MS No.: nhess-2022-35

Response to review comments by Anonymous Referee #1 (R1)

Figure 1 the process of determination of parameters

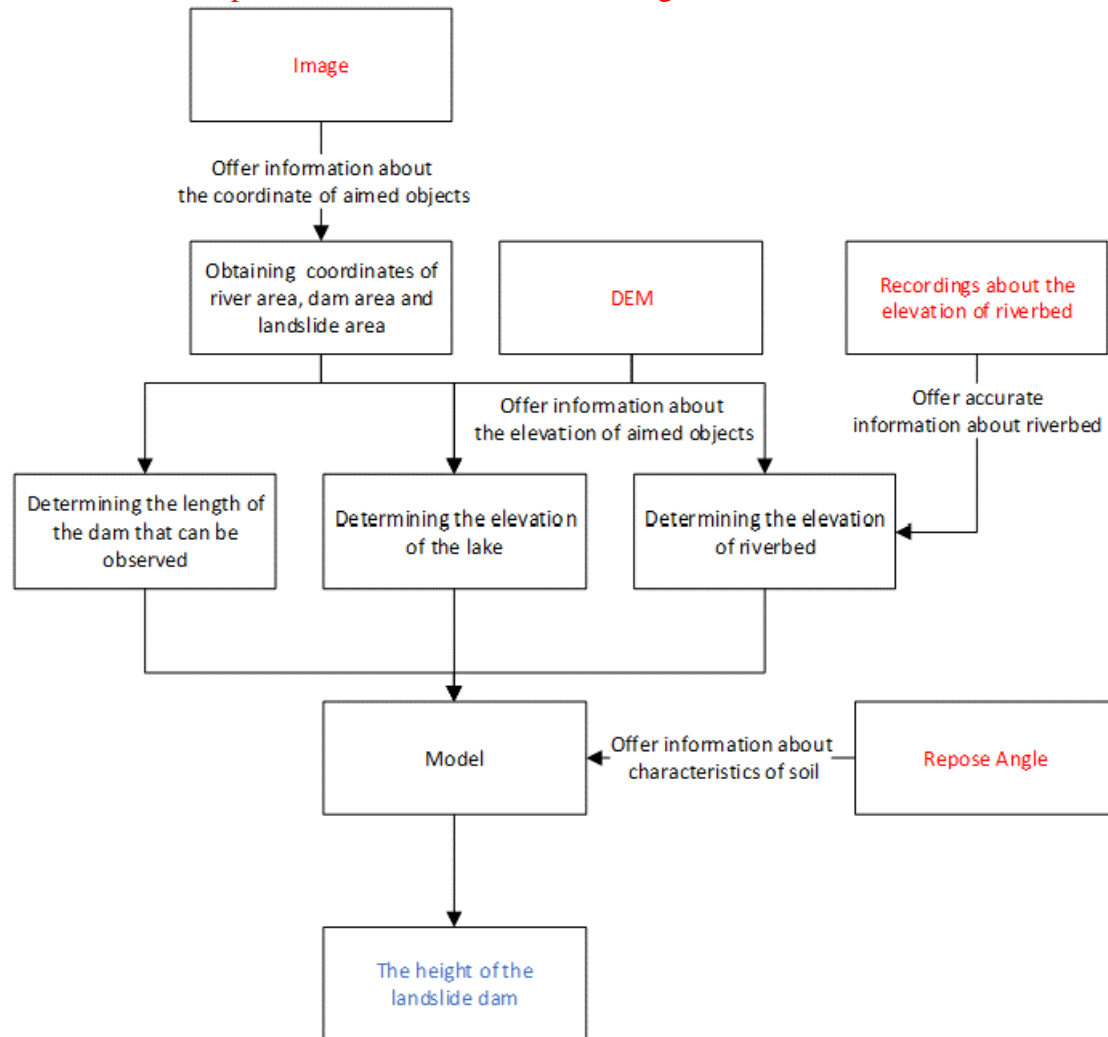
The section should be supplemented with a figure, explaining the complete process of determination of parameters.

Thank you for your advice. The rough figure that explains the process of determination of parameters is showed as following.

These words in red means the input data. The characteristics of them is shown in **Figure 1 before**. And we will give a more formular figure in our revised manuscript.
